# UNITED STATES PATENT AND TRADEMARK OFFICE

10/730,456

## Office Action Summary

FIG. 2.

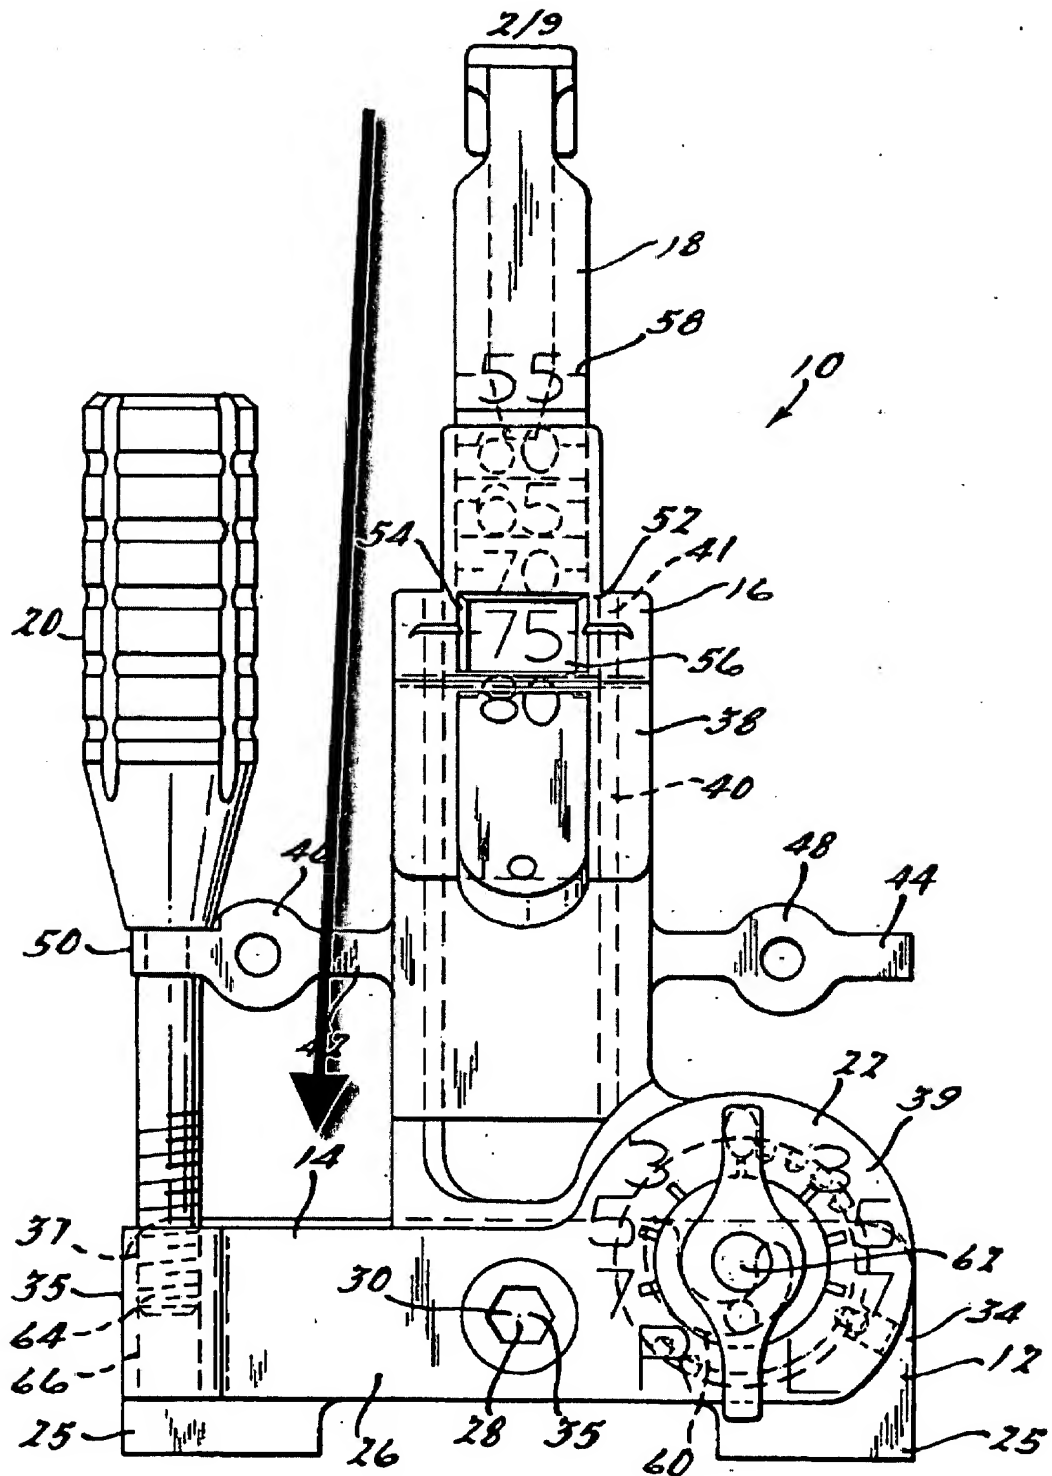
The drawings are objected to as failing to comply with 37 CFR 1.84(p)(4) because reference character "14" has been used to designate a base portion in Figs. 1 and Fig. 2. These are two separate portions denoting the same subject matter and is thus conflicting. See drawings below. Corrected drawing sheets in compliance with 37 CFR 1.121(d) are required in reply to the Office action to avoid abandonment of the application. Any amended replacement drawing sheet should include all of the figures appearing on the immediate prior version of the sheet, even if only one figure is being amended. Each drawing sheet submitted after the filing date of an application must be labeled in the top margin as either "Replacement Sheet" or "New Sheet" pursuant to 37 CFR 1.121(d). If the changes are not accepted by the examiner, the applicant will be notified and informed of any required corrective action in the next Office action. The objection to the drawings will not be held in abeyance.

Item 14 defined as base:

Item 14 defined as base:

It is further noted that as mentioned earlier, item 14 is pointing to TWO DIFFERENT ITEMS in the drawings. In only one instance of the drawings or one of the two options provided by the drawings, could this possibly occur. Thus, the support for these claims is DELIBERATELY MISLEADING.

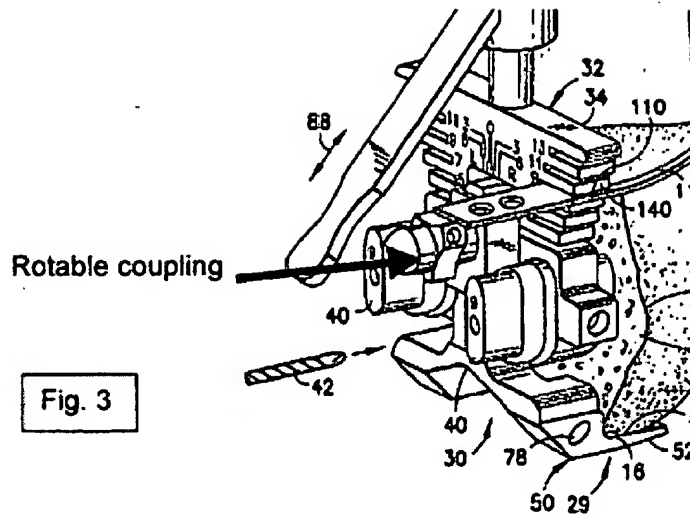
Claims 1, 8, 34, 36-37, and 41-42 are rejected under 35 U.S.C. 102(b) as being anticipated by Harwin et al. (US Patent 6,458,135). Harwin et al. disclose a femoral guide having an extension portion (30) configured to be adjacent to a posterior condyle surface to the femur, a base portion (32), a superstructure (90) and a graduated stylus (80) that is *configured* to be adjacent to the anterior condyle surface of the femur. It is further noted that language "configured to" has been held that performing a function is not a positive limitation but only requires the ability to perform. It does not constitute a limitation in any patentable sense. *In re Hutchison*, 69 USPQ 138. Harwin et al. further disclose a device with a pair of feet (52, the second foot hidden in Fig. 3), the extension is rotably coupled to the base (See Fig. 3 below)

Contrary to the arguments as disclosed by applicant on 7/24/2006, the Harwin reference DOES teach that the base may be rotably coupled to the base. Harwin discloses that 60 is a "pivotal connection" and further that the device includes (65) markings to better fit various angles. See also Fig. 2, lines 35-50). Further, the device of Harwin et al. disclose a slot to restrain the movement of the stylus (96) that is also capable of being rotably coupled and is substantially parallel.
